WINSOME FILING NO. 3  
EL PASO COUNTY, COLORADO  
CONSTRUCTION DOCUMENTS  
CROSS SECTIONS

PROJECT NO.  
196106001

WINSOME FILING NO. 3  
 EL PASO COUNTY, COLORADO  
 PRE DEVELOPMENT GESC PLAN  
 GEC FINAL PLAN

**ROADWAY CROSS SECTIONS**

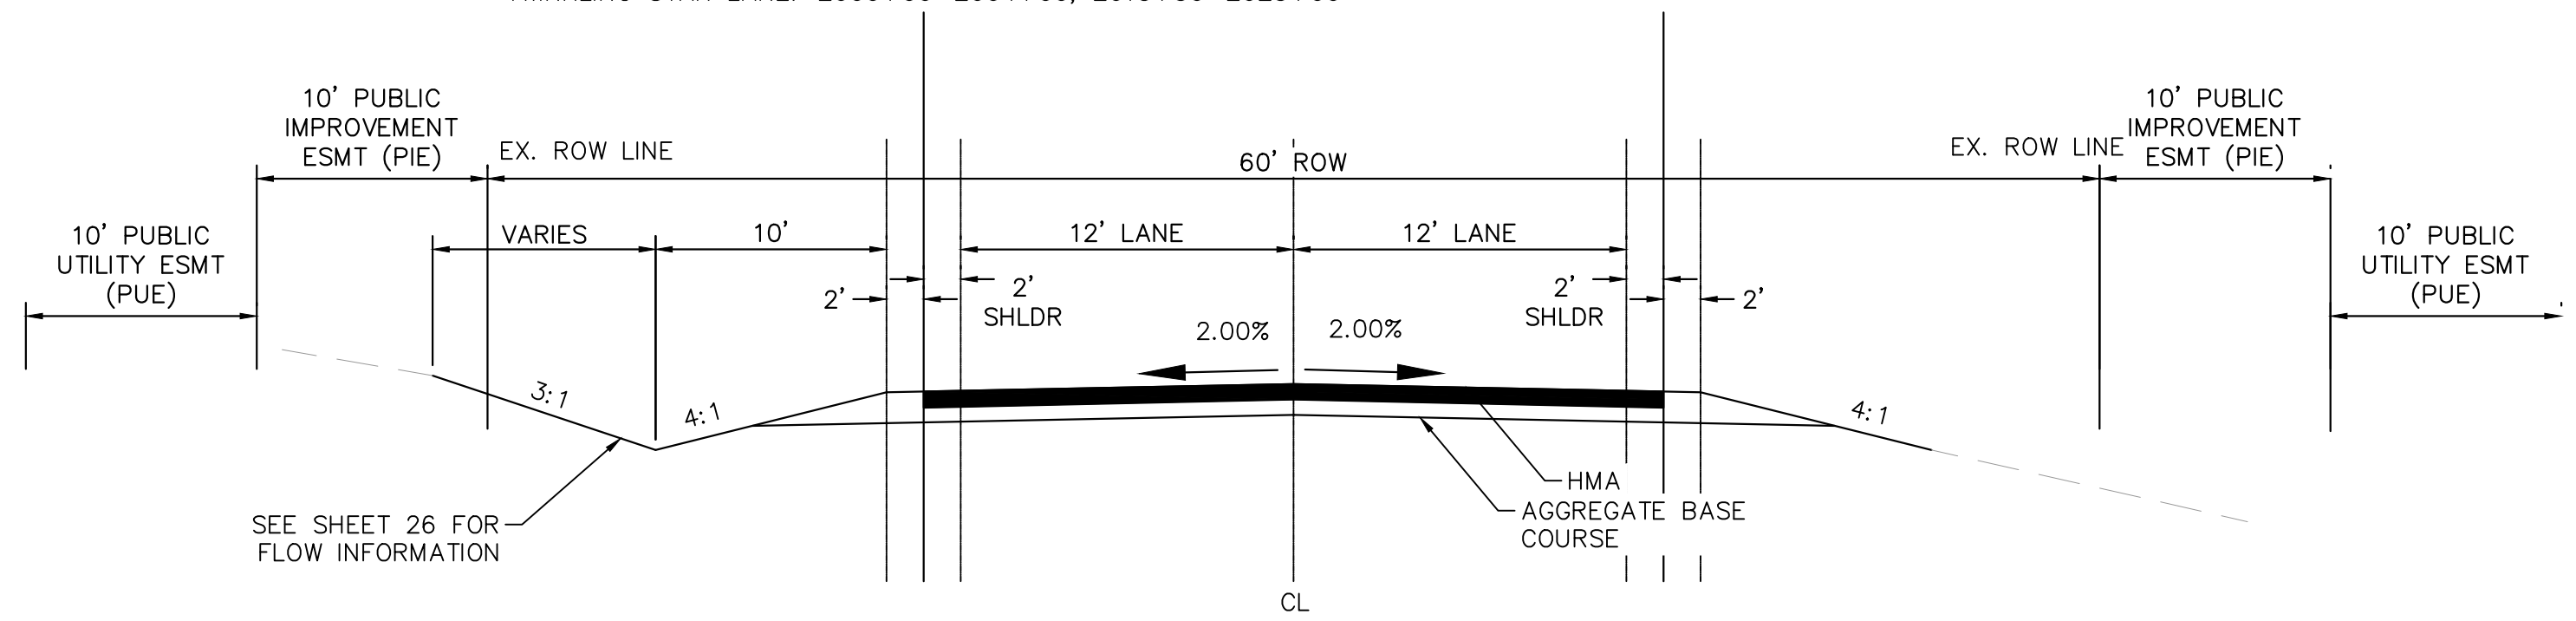
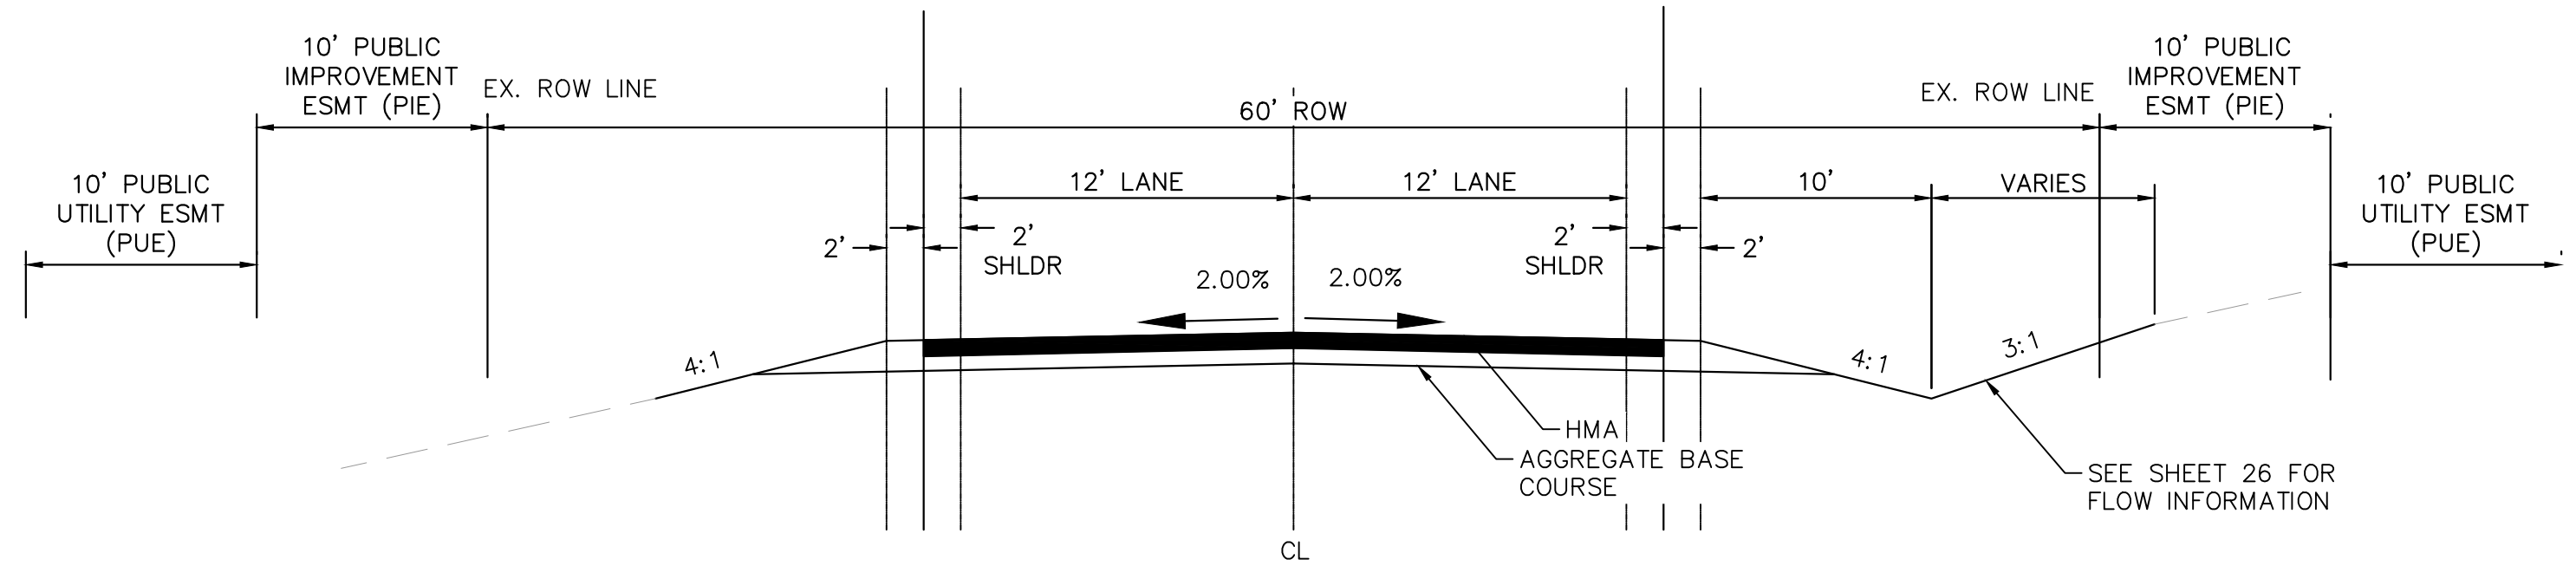
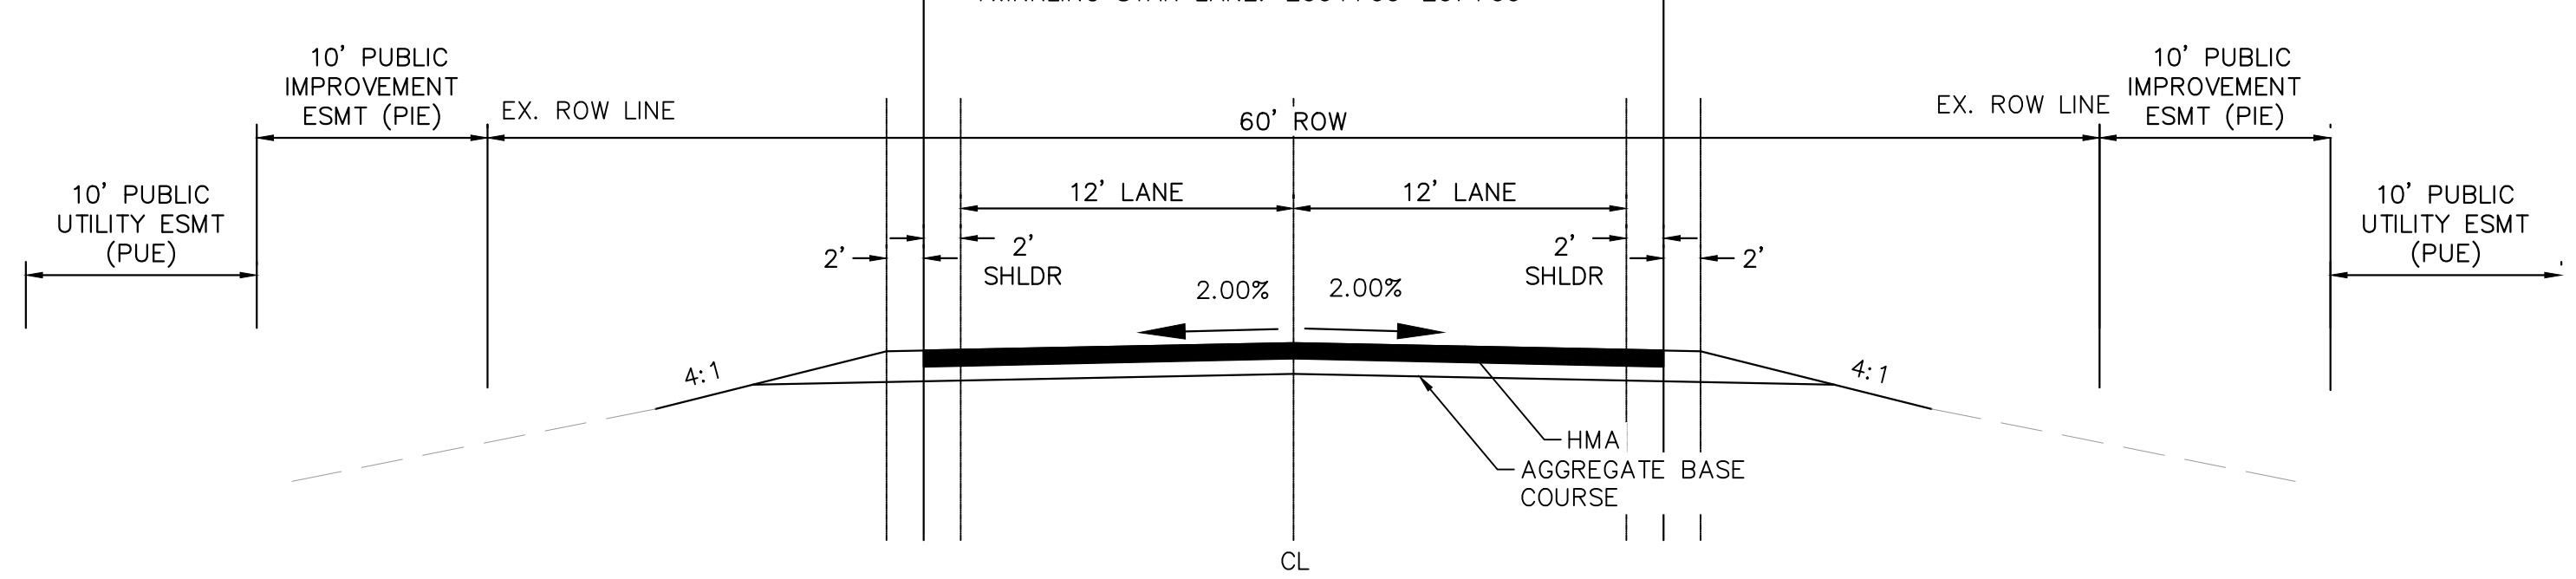
Specify the gravel used.

Gravel/Aggregate is now specified

WINSOME FILING NO. 3  
EL PASO COUNTY, COLORADO  
CONSTRUCTION DOCUMENTS  
**ALAMAR PLAN AND PROFILE**

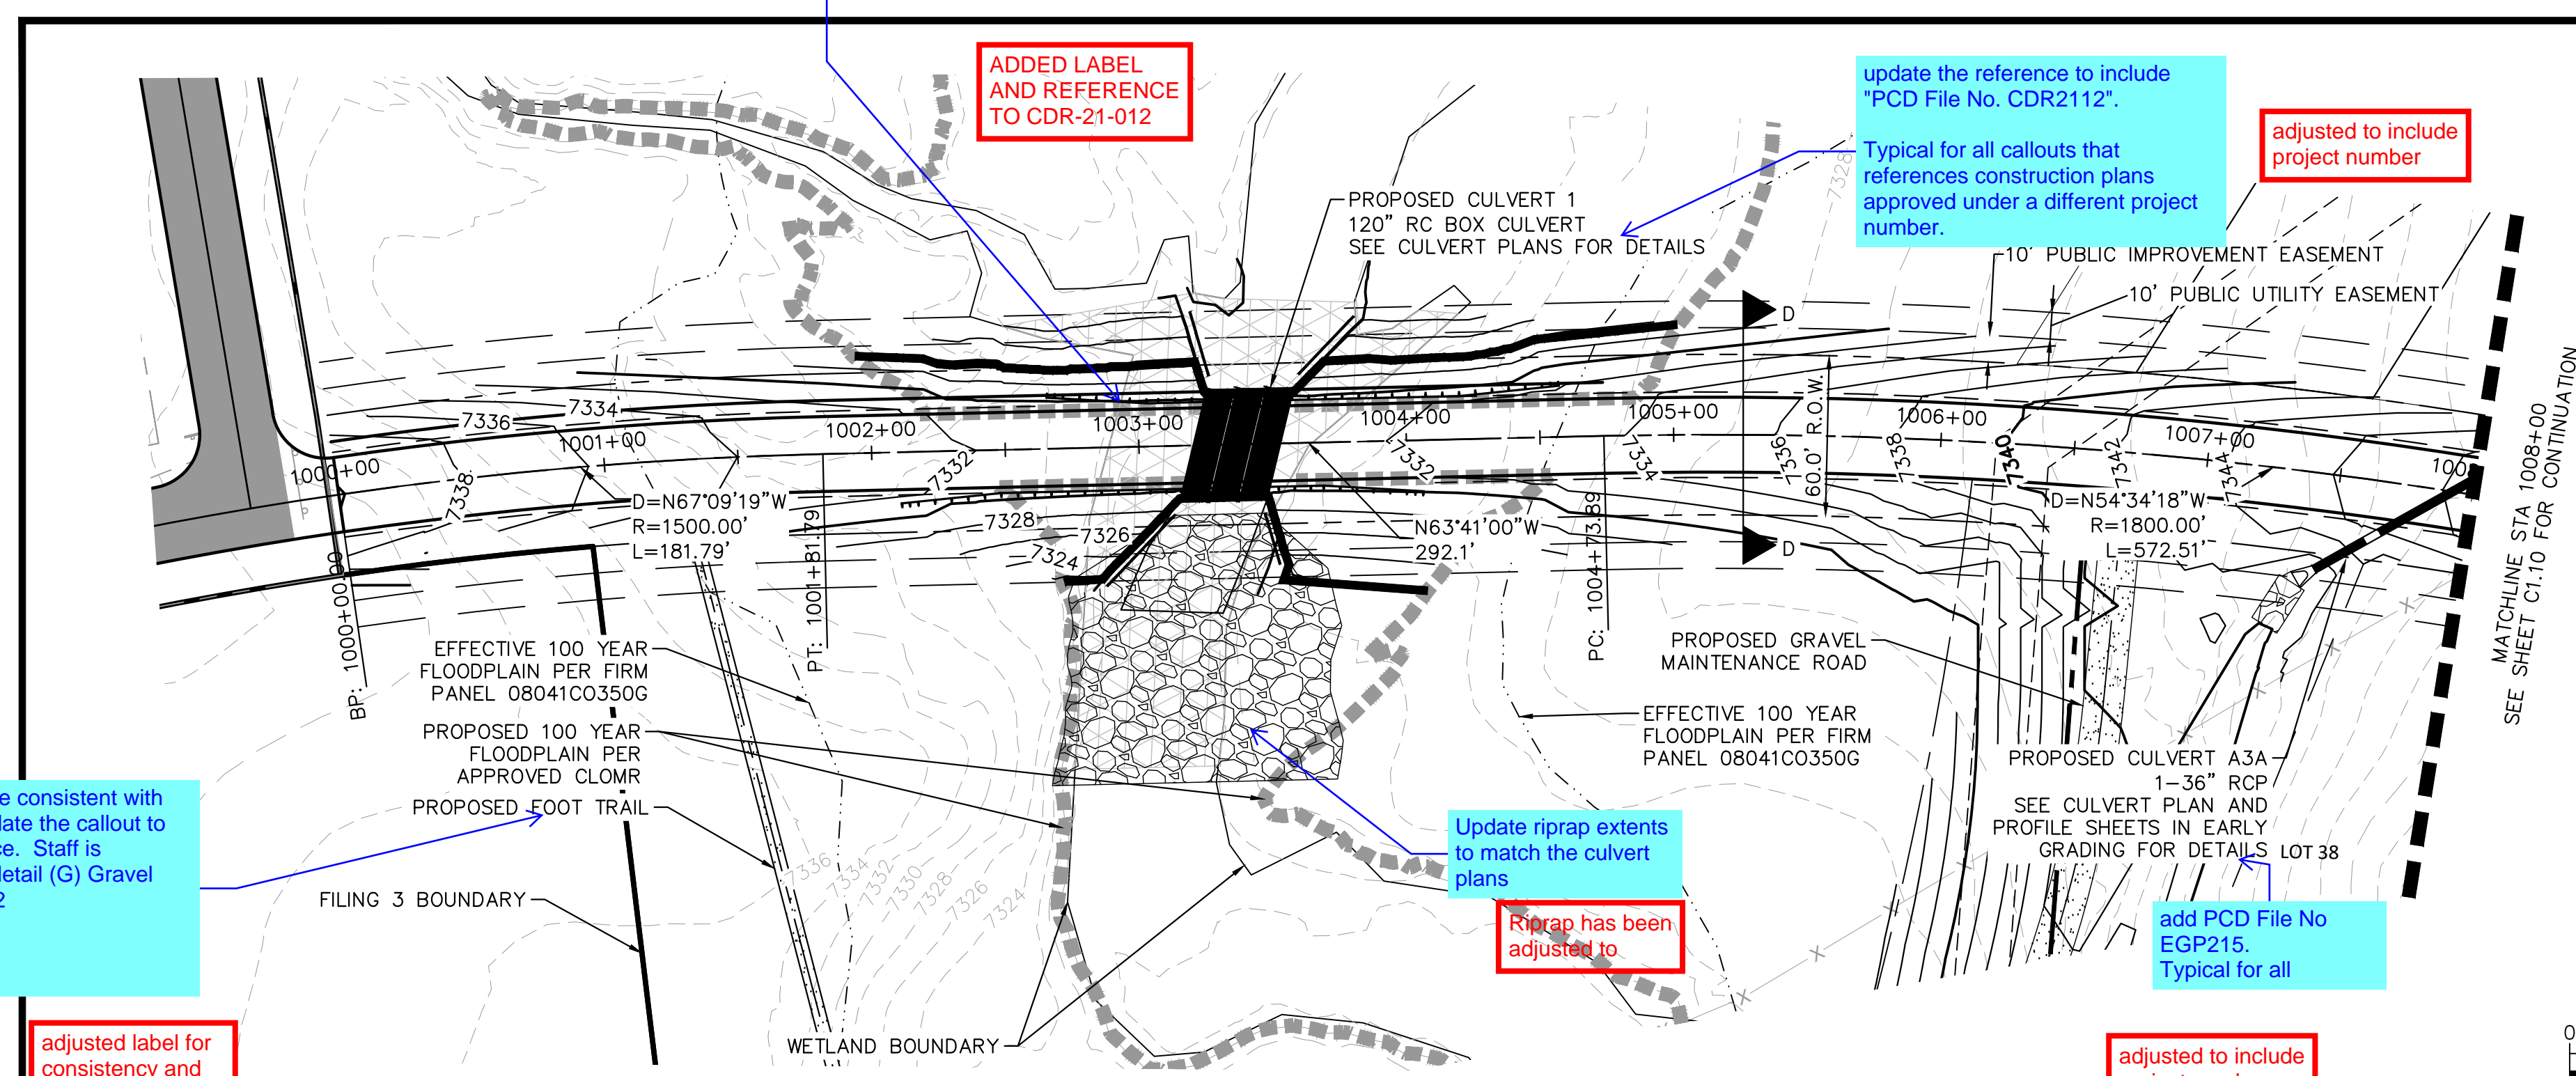
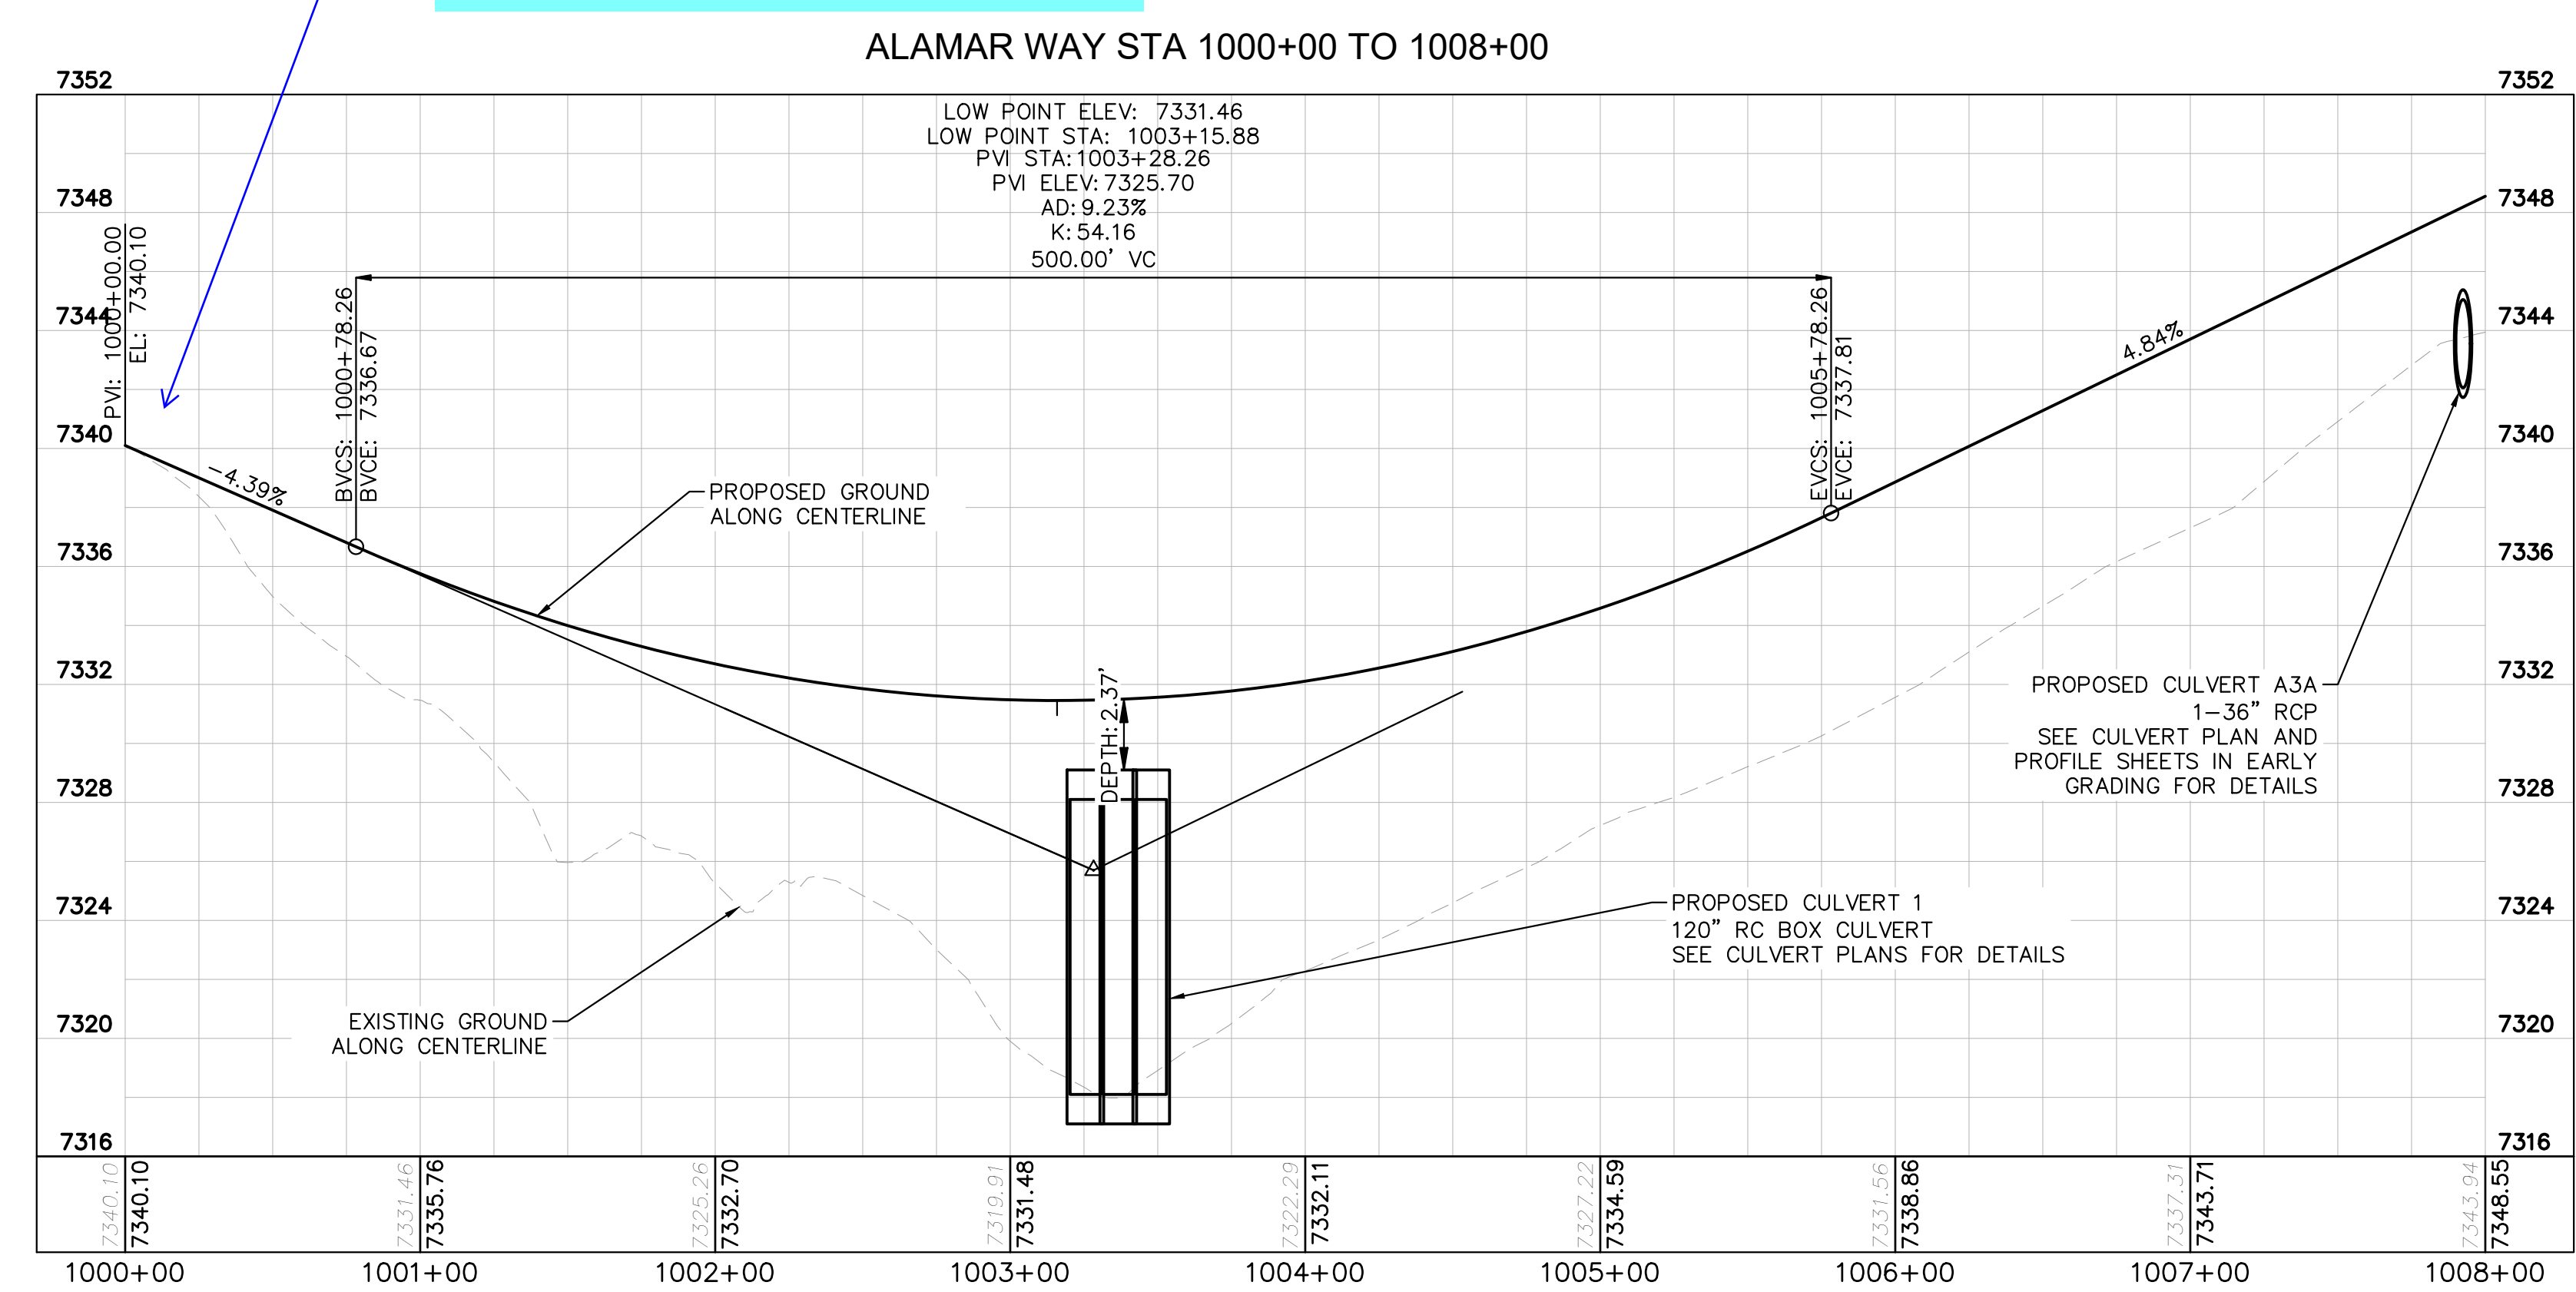
Revise name to be consistent with the detail and update the callout to include a reference. Staff is assuming this is detail (G) Gravel Trail in sheet C1.2

label the guardrail and reference which plan contractor needs to look at for construction details or include in this plan set.

update the reference to include "PCD File No. CDR2112".  
Typical for all callouts that references construction plans approved under a different project number.

Update riprap extents to match the culvert plans

Adjust intersection grade. Per ECM Table 2-22 and 2-23 the approach grade to the intersection must be 1% min to 4% max for a distance of 100 ft.

ADDED LABEL AND REFERENCE TO CDR-21-012

adjusted to include project number

Riprap has been adjusted to

adjusted to include project number

adjusted label for consistency and included reference to C1.2

Intersection Grade and Profile has been adjusted
